Addendum No. 6, July 11th, 2025

Re: Johnson Hall Renovation – PKG 3
Johnson Hall Renovation & Foster Demolition
Tennessee Technological University
SBC Project No. 364/011-04-2022CM

JOB NO.	22025
ISSUE DATE	3-28-25
SHEET TITLE	ROOF DETAILS
DRAWN	CWD
REVIEW	KAC
	A5.12

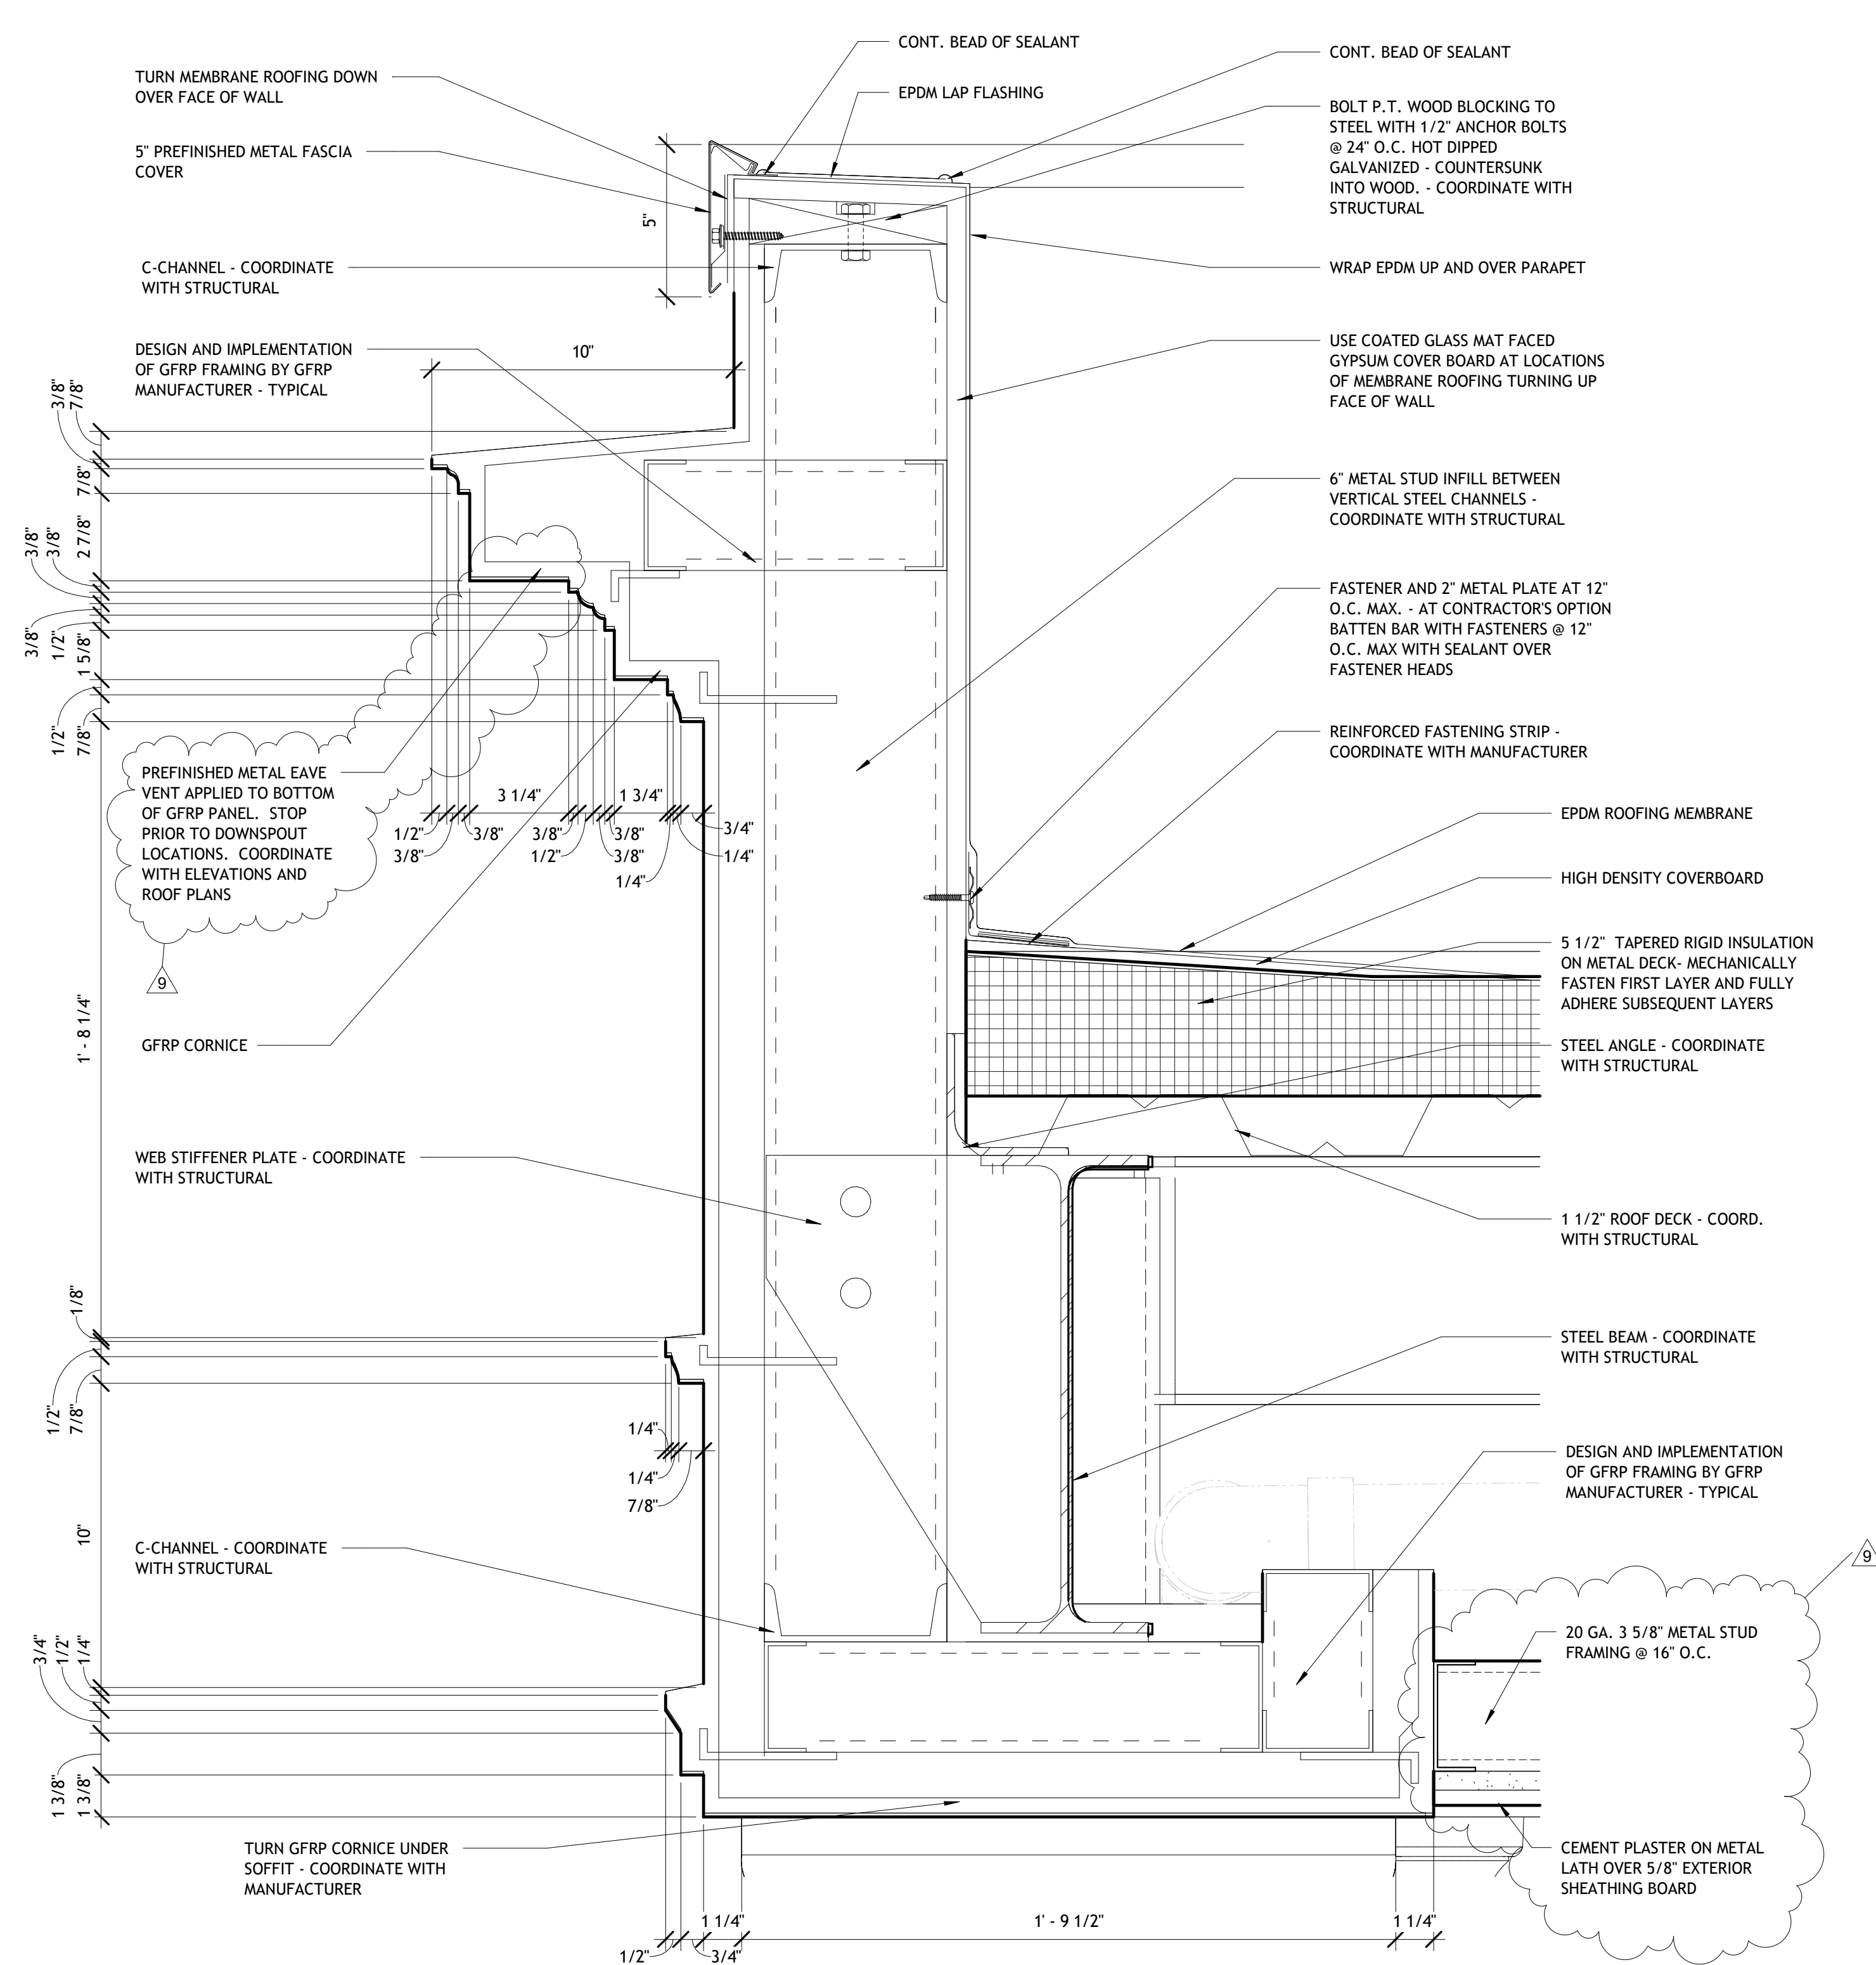
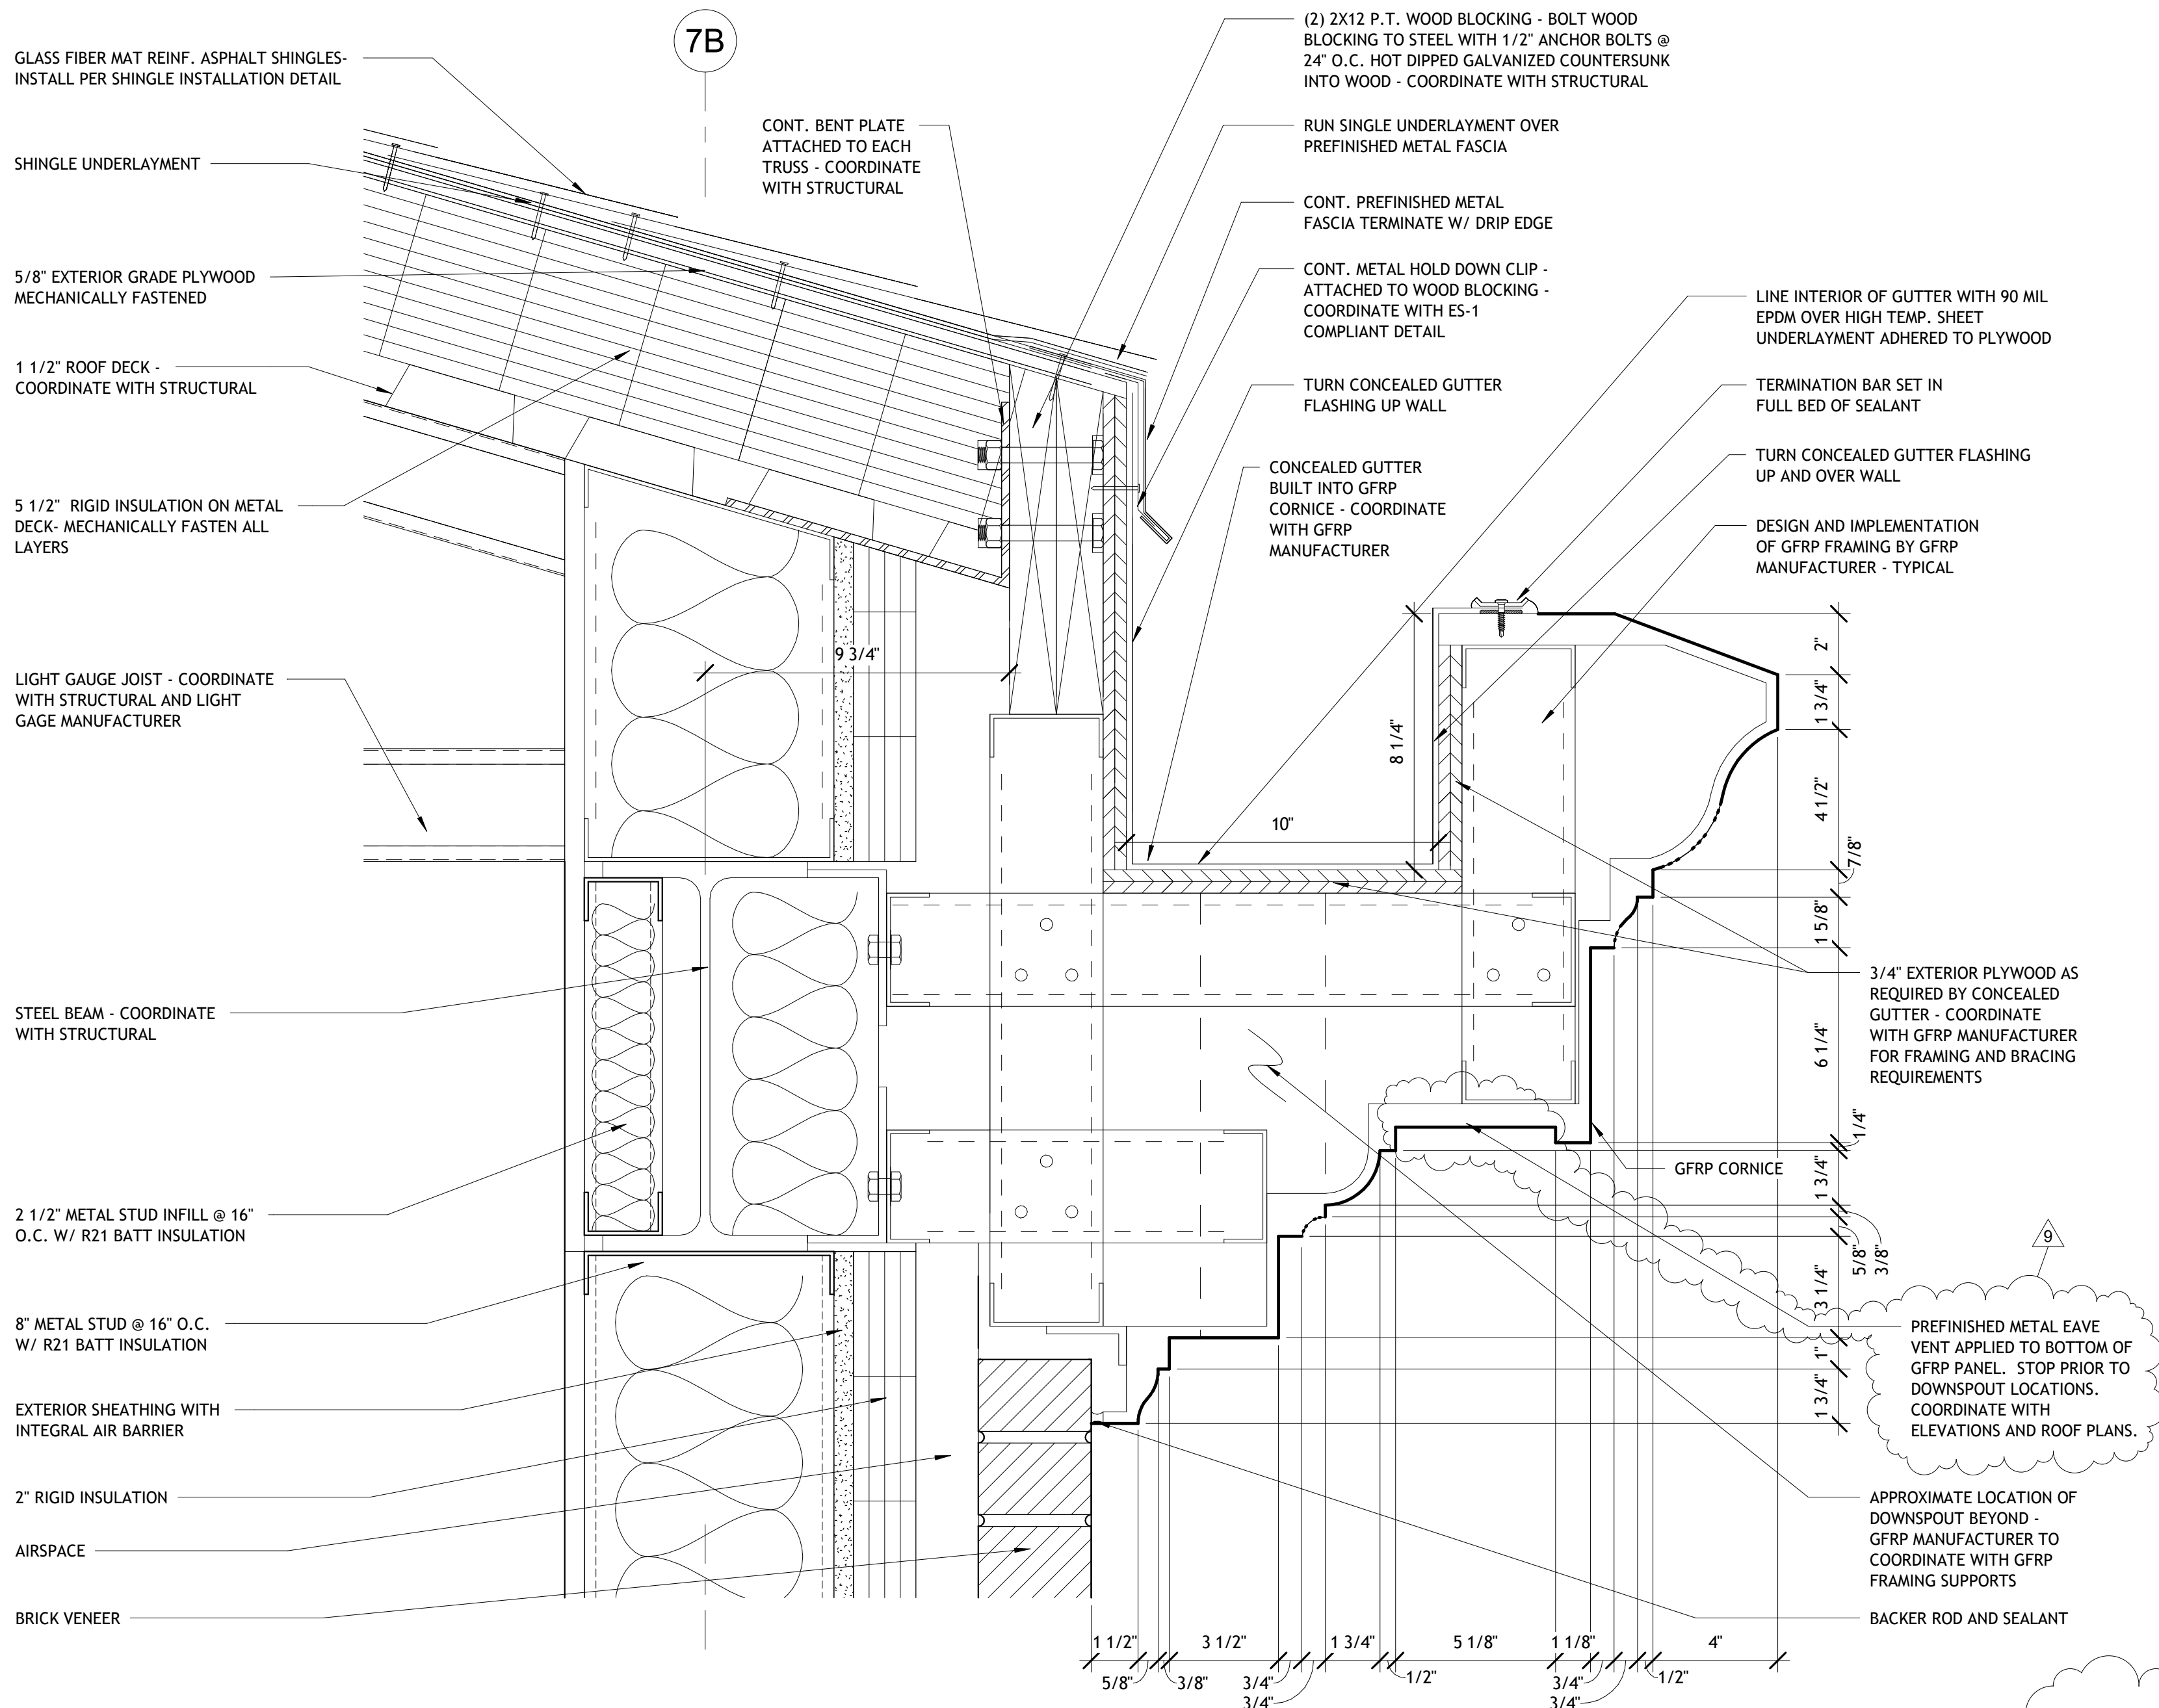
- 12) Refer to sheet A4.22 details 1 and 2. Change portico material to cement plaster on metal lath over 5/8" exterior sheathing board.
- 13) Refer to Sheets A5.12, A5.13, A5.14, and A5.15. Add prefinished metal eave vent applied to bottom of GFRP panel to locations shown on revised details.

- 14) Refer to sheets A5.12, A5.14 and A5.15. Change soffit at front portico, back portico and above exterior balcony to be a cement plaster on metal lath over 5/8" exterior sheathing board on 20 GA 3 5/8" metal stud framing @ 16' o.c.
